**COMMUNITY SERVICES DEPARTMENT**

**Subject: Lorson Ranch Sketch Plan Amendment No. 2 (SKP191)**

The Planning Division of the Community Services Department has reviewed the Lorson Ranch Sketch Plan Amendment No. 2 and has the following comments on behalf of El Paso County Parks. This application will be presented to the El Paso County Park Advisory Board on February 13, 2019.

**Lorson Ranch Sketch Plan  
Amendment No. 2**

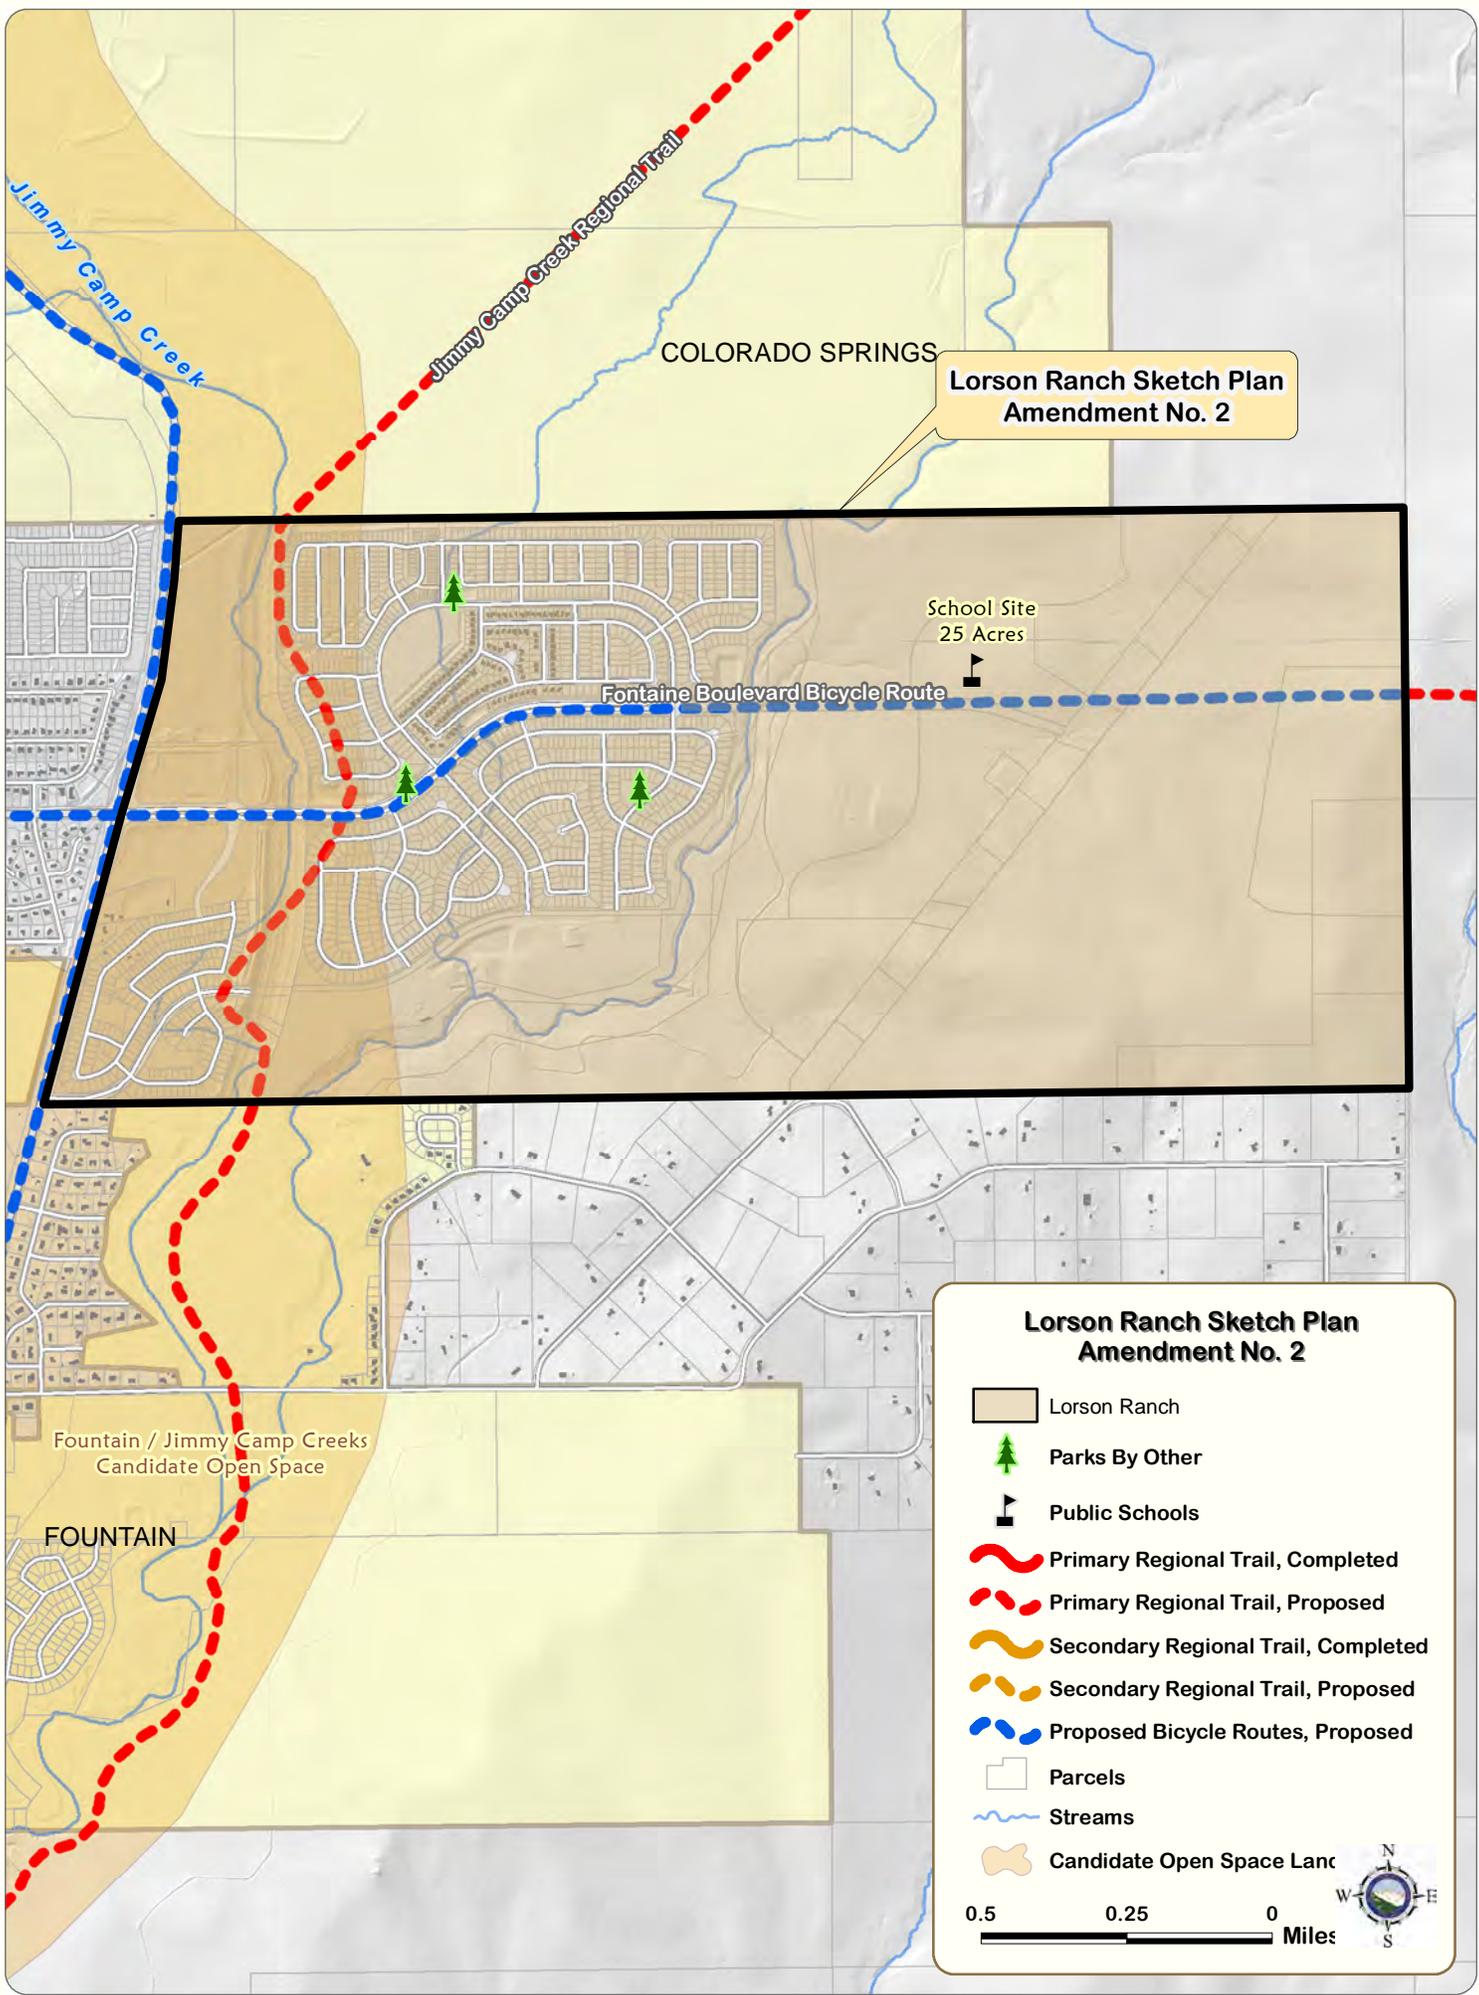
Consistent with the LDC, land uses, including open space, trail and park locations, should be conceptually identified on the sketch plan. Lots shall have reasonable access to open space, trails, park land or recreational facilities that are set aside for either homeowner use or use by the general public. Please include conceptual trail locations and identify acreages of future park and open space areas east of the East Tributary. All future park locations should be labeled and sized according to their type (e.g. neighborhood, community) per LDC Section 8.5.2. The breakdown of required urban park is as follows:

The County Parks Master Plan shows the Fontaine Boulevard Bicycle Route within the sketch plan area along Fontaine Boulevard. This bicycle route will be accommodated within County right-of-way and installed as part of future road improvements. There are no County regional trails within the sketch plan areas; however non-County trails were shown on previously approved sketch plans, and subsequent PUD's and Preliminary Plans. Please show all proposed trail alignments, park sites, and open space areas on the sketch plan drawings as required by the Land Development Code.
